RE: PZ# 24-12000026 Minor Site Plan (KAJA Fleet Vehicle Wash @ W Atlantic Boulevard
Pompano Beach, FL 33060, folios 484234500010; 484234500020)

Thank you for providing us with comments at the April 2nd, 2025 Pre-Application Meeting. We would like to take the opportunity to respond to those comments issued from at this time. If you believe the comments have been satisfied and the project can move forward, please indicate so.

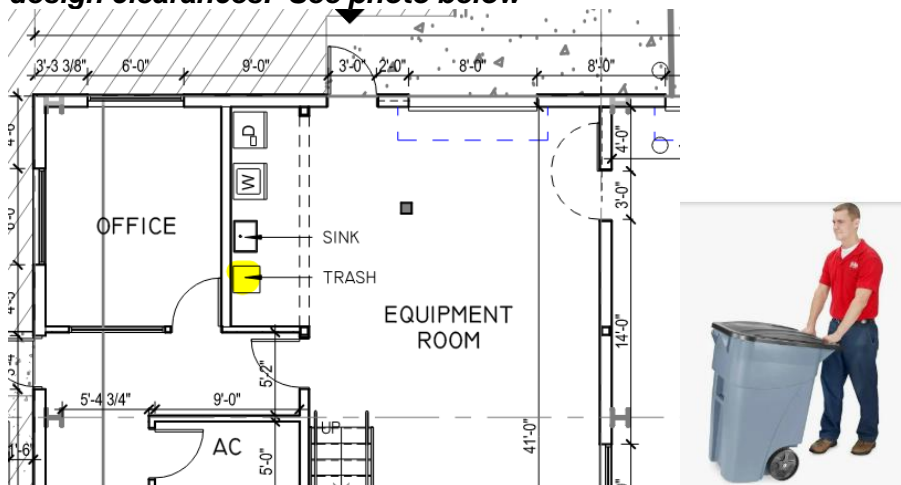
19. On the elevation provide material call outs.

Response: Sheet A-201 has colors and materials called out.
